Before and after change comparison

Current product	Alternative
Type No.	S1133-14	S16765-01MS
Image		
Dimensional outline

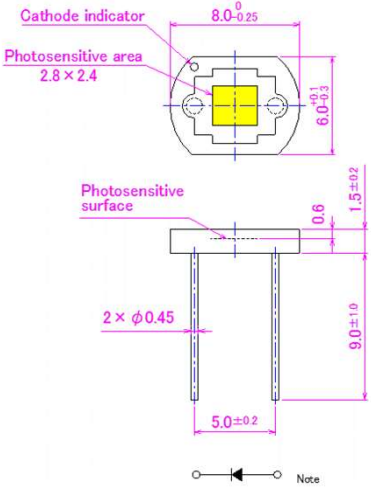
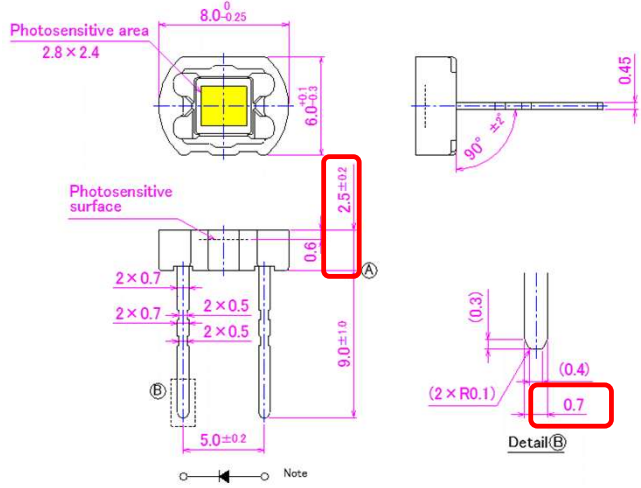
Current product	Alternative
		S1133-14	S16765-01MS
Material	Package	Ceramic	Plastic
	Lead material	Fe · Ni · Cobalt alloy	Cu · Zinc alloy
	Lead plating	Au	Pd/Au
	Filling resin	Epoxy	Silicone
	Photodiode	No change	
Machine		Mitsue factory	Shingai factory
Man		Mitsue factory	Shingai factory
